WEST SUSSEX COUNTY COUNCIL CONSULTATION

TO:	<u>Arun</u> District Council <u>FAO:</u> Katie Sharp
FROM:	<u>WSCC</u> - Highways Authority
DATE:	22 April 2022
LOCATION:	Land off <u>Arundel</u> Road <u>Angmering</u> <u>BN16 4ET</u>
SUBJECT:	A/48/22/RES Approval of reserved matters following A/122/19/OUT and <u>varied</u> by A/207/21/PL pertaining to the layout, scale, appearance and landscaping for 160 No dwellings. This application is a Departure from the Development Plan and is in CIL Zone 3 and is CIL Liable as new dwellings.
DATE OF SITE VISIT:	<u>n/a</u>
RECOMMENDATION:	More Information / Modification
<u>S106</u> CONTRIBUTION TOTAL:	<u>n/a</u>

Vehicle Tracking

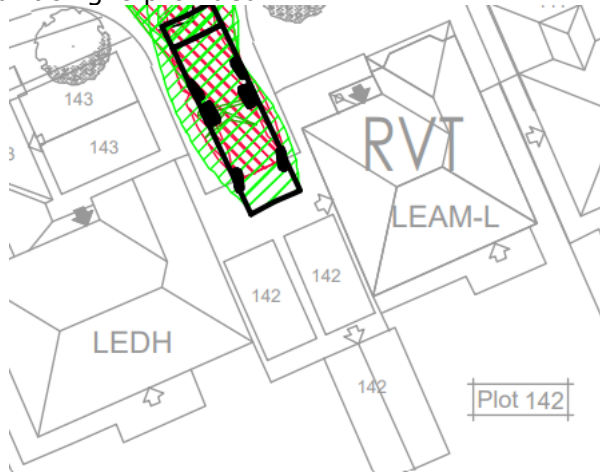
Tracking has been provided for a fire tender and refuse vehicle and are acceptable. It is noted that in some areas the tracking would extend off the carriageway on to what maybe a residential curtilage. This boundary should be checked and ensured a suitable surfacing is provided.

Visibility

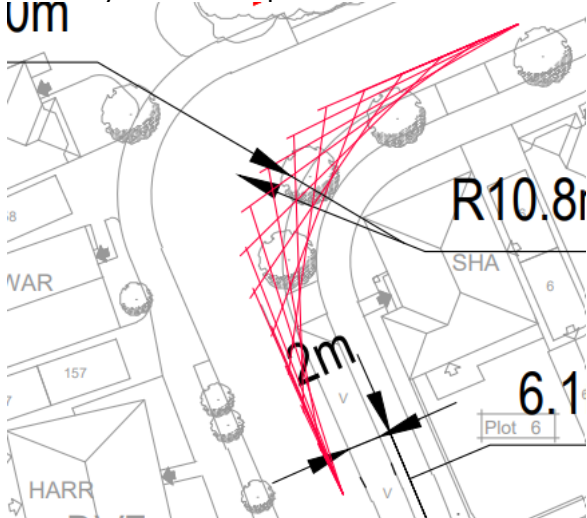
In a number of locations the forward visibility around the bend would be obstructed by the proposed tree planting. Further details on the type of trees proposed and impact on visibility should be provided.
